**NRC RAI Letter No. PTN-RAI-LTR-040**

**SRP Section: 02.05.04 - Stability of Subsurface Materials and Foundations**

**NRC RAI Number: 02.05.04-17 (eRAI 6006)**

**Figure 1**  
 Factor of safety against liquefaction based on CPT values  
 (reproduced from FSAR Figure 2.5.4-238)

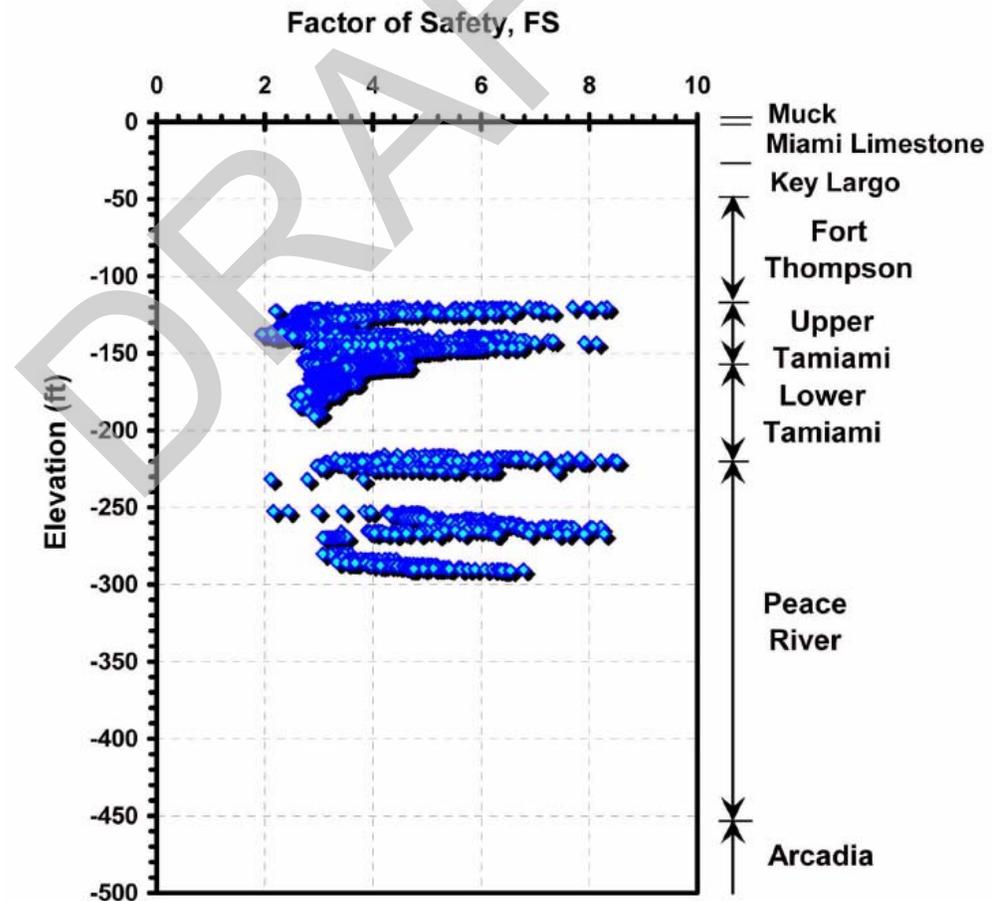
The calculation for "Site Response and Strain Compatible Properties Calculation" Rev. 001 describes the procedure used to calculate stresses in the liquefaction analysis. In accordance with NUREG-0800, Standard Review Plan, Chapter 2.5.4, "Stability of Subsurface Materials and Foundations," and Regulatory Guide (RG) 1.198, "Procedures and Criteria for Assessing Seismic Soil Liquefaction at Nuclear Power Plant Sites" please clarify the following regarding the methodology used to calculate the CSR (cyclic stress ratio):

- a. Clarify how the method used for determining  $SR_{DRS}$  meets the ground motion level requirements for liquefaction analysis per 10 CFR 50, Appendix S. The  $GRMS$  initially resulted in a  $PGA$  of less than 0.1g and was scaled upwards per RG 1.208. Since the method used for determining the  $SR_{DRS}$  is the same as the  $GRMS$ , describe how this method provides stress ratio values that are comparable to those calculated using a  $PGA$  value of at least 0.1g.

The factor of safety (FOS) against liquefaction is computed by dividing the strength (capacity) of the soil available to resist liquefaction (cyclic resistance ratio or CRR) by the stresses (demand) in the soil caused by the earthquake (cyclic stress ratio, CSR, or simply SR as used in the question). For Units 6 & 7, the evaluation of the soil strength was primarily based on cone penetration test (CPT) results. The methodology that was applied to the computation of FOS values in FSAR Subsection 2.5.4.8 utilized the CSR values obtained from the site-specific ground response (P-Shake) analysis. This RAI response re-evaluates the FOS against liquefaction by directly computing the CSR values using the Seed simplified equation (FSAR Subsection 2.5.4 Reference 219) with a peak ground acceleration (PGA) of 0.1g.

FSAR Figure 2.5.4-238, which is reproduced as Figure 1 in this response, is a compilation of the four CPT data sets and presents the FOS values that are based on the CSR values from P-Shake analysis as a function of elevation. The three lowest FOS values that correspond to the CPT measurements at three different elevations are selected from this figure for comparison purposes. The FOS of 1.92 at El. -137.7 ft, 2.11 at El. -231.5 ft, and 2.16 at El. -252.3 ft (NAVD 88) are tabulated below, along with their corresponding CSR values of 0.047, 0.043, and 0.043.

For re-evaluation purposes, the CSR values for the same data points are recalculated using a PGA of 0.1g. Using Equations 1, 2a and 2b of FSAR Subsection 2.5.4 Reference 219, the corresponding CSR values are computed as 0.060, 0.064, and 0.065, respectively. Thus, the CSR values based on a PGA of 0.1g are increased compared to those directly obtained from the site-specific P-Shake analysis. As a result, because there is an inversely proportional relationship between the CSR and FOS values, substituting the CSR values from 0.1g will reduce the corresponding FOS values. Thus, the FOS values computed using a PGA of 0.1g at El. -137.7 ft, -231.5 ft, and -252.3 ft are 1.50, 1.42, and 1.43, respectively. As indicated in FSAR Subsection 2.5.4.11, the minimum allowable FOS of 1.25 was conservatively selected as the trigger value for the liquefaction analysis of site soils. Given that RG 1.198 considers soils with a FOS value less than 1.1 as liquefiable, there is about 14% conservatism employed in the analysis (1.1 versus 1.25). Nonetheless, the FOS values of 1.50, 1.42, and 1.43 exceed the minimum allowable FOS of 1.25.

In summary, using a PGA of 0.1g in calculation of CSR values will reduce the FOS values against liquefaction. However, as observed above, the latter FOS values exceed the minimum allowable FOS of 1.25. Thus, no modifications are proposed to the approach presented in the FSAR.

The footnote to FSAR Figure 2.5.4-238 will be deleted as follows in a future FSAR revision.

~~Data from Reference 257~~

**Figure 2**

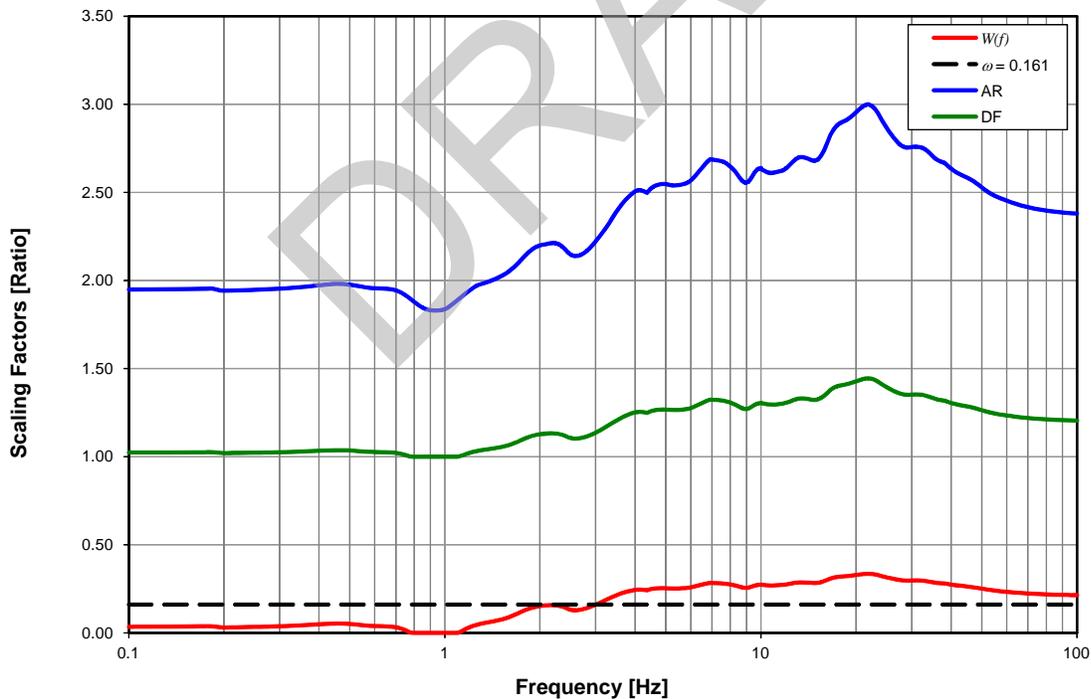
- b. Describe how the amplitude ratio  $A_R(f)$ , defined by  $(ARS_{10-5}) / (ARS_{10-4})$  and used in the determination of the weighting factor  $w$ , correlates to the ratio of the in-situ *stress ratios* resulting from site response analysis using the  $ARS_{10-5}$  and  $ARS_{10-4}$  as input spectrums.

The weighting factor approach results in stress ratios that are compatible with the design response spectrum (DRS), that is larger than stress ratios compatible with 1E-4 seismic motion, and lower than stress ratios compatible with 1E-5 seismic motion. The amplitude ratio  $A_R(f)$  correlates positively to the weighting factor  $W(f)$  as shown in Figure 2. Stress ratios are calculated using the following equation:

$$SR_{DRS} = (SR_{10-4})^{1-\omega} (SR_{10-5})^{\omega}$$

Where  $\omega$  is the average  $W(f)$  over the entire frequency range. Note that the larger the value of  $\omega$  the smaller the contribution of  $SR_{10-4}$  and the larger the contribution of  $SR_{10-5}$ . Therefore, the amplitude ratio  $A_R$  also correlates positively to the resulting stress ratios  $SR_{DRS}$ .

**Figure 3**

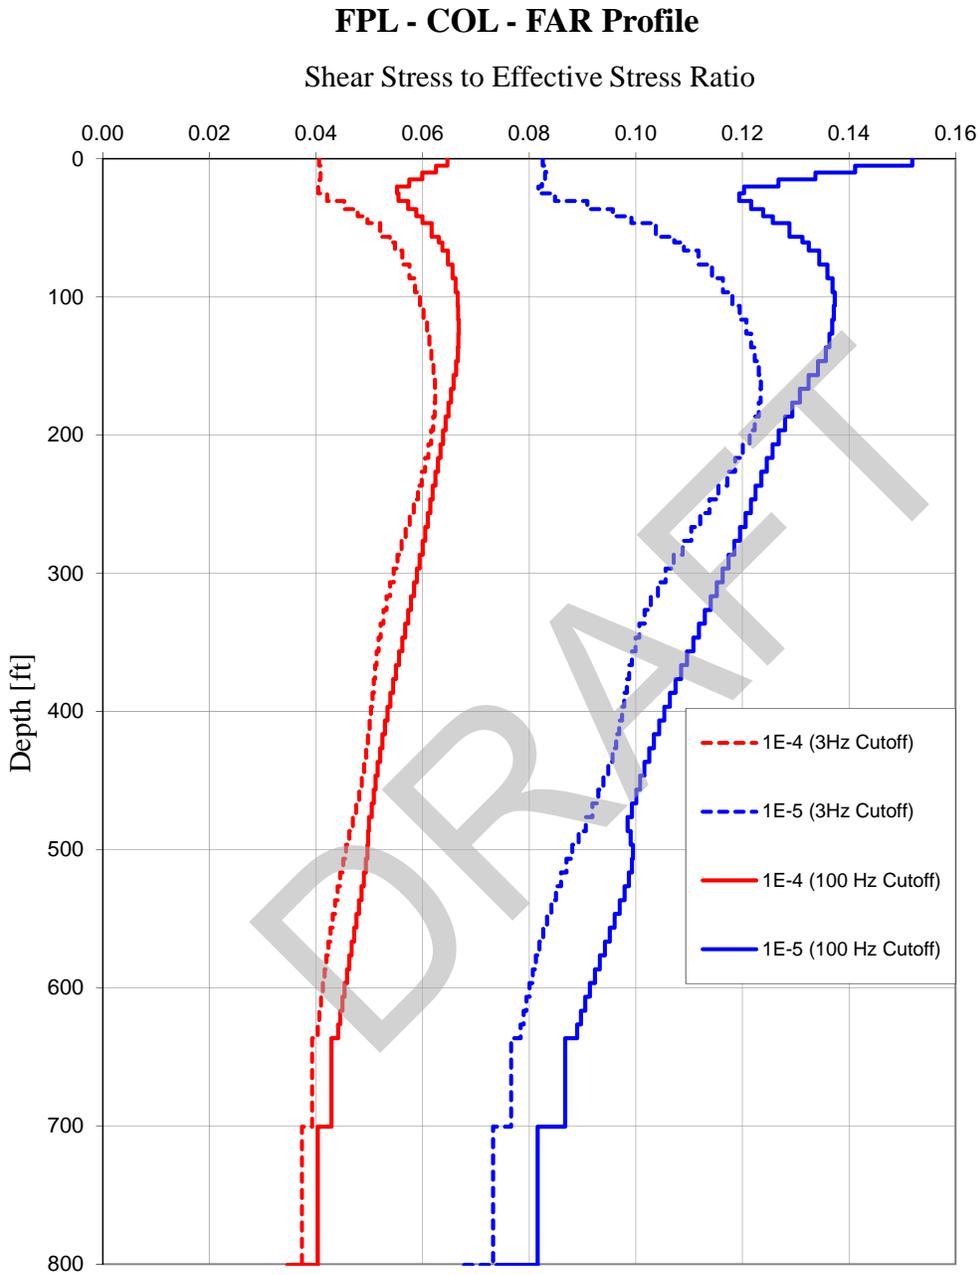
- c. The weighting factor  $w$  applied to the stress ratios  $SR_{10-4}$  and  $SR_{10-5}$  for the determination of  $SR_{DRS}$  is based on the average of the weighting factor  $W(f)$ . Justify using an average value of  $W(f)$  over all frequencies, and describe how this is a conservative approach.

The average weighting factor  $w$  is larger than the calculated frequency-dependent weighting factors below a frequency of 3 Hz, but smaller at frequencies larger than 3 Hz. To justify the adequacy of the adopted average weighting factor for the purpose of calculating conservative stress ratios for use in liquefaction analysis, the following was performed.

The site response analysis runs, using P-SHAKE, are repeated for the FAR soil column with an imposed cutoff frequency of analysis of 3 Hz, as opposed to the cutoff frequency of 100 Hz in the case of the original analysis. The analysis was performed for all 60 simulated profiles subjected to the low frequency (LF) and high frequency (HF) rock motions at the 1E-4 and 1E-5 hazard levels. The resulting stress ratios, which as in the case of the original analysis are the envelope of LF and HF results, are compared in Figure 3 at the 1E-4 and 1E-5 hazard levels. Noting that the top-most submerged granular soil layer, analyzed for potential liquefaction, is at a depth of around 145 ft (Elevation -120 ft), it follows that the contribution of the motion, with frequency content removed above 3Hz, is more than 90% of the total stress ratios for all layers.

From Figure 2, note that for frequencies below 3 Hz the calculated frequency dependent weighting factor is much smaller than the adopted weighting factor of 0.161 used in the stress ratio calculation, with a computed average weighting factor of 0.054 for frequencies below 3 Hz. Similarly, in the case of the near NI soil column, and for frequencies below 3 Hz, the average weighting factor is 0.060, which is smaller than the adopted weighting factor of 0.154 used in the stress ratio calculation.

It is therefore concluded that the adopted (larger) weighting factor is conservative and adequately compensates for any small contribution to the weighting factor from frequencies above 3 Hz, confirming the adequacy of the calculated stress ratios used in liquefaction analysis.
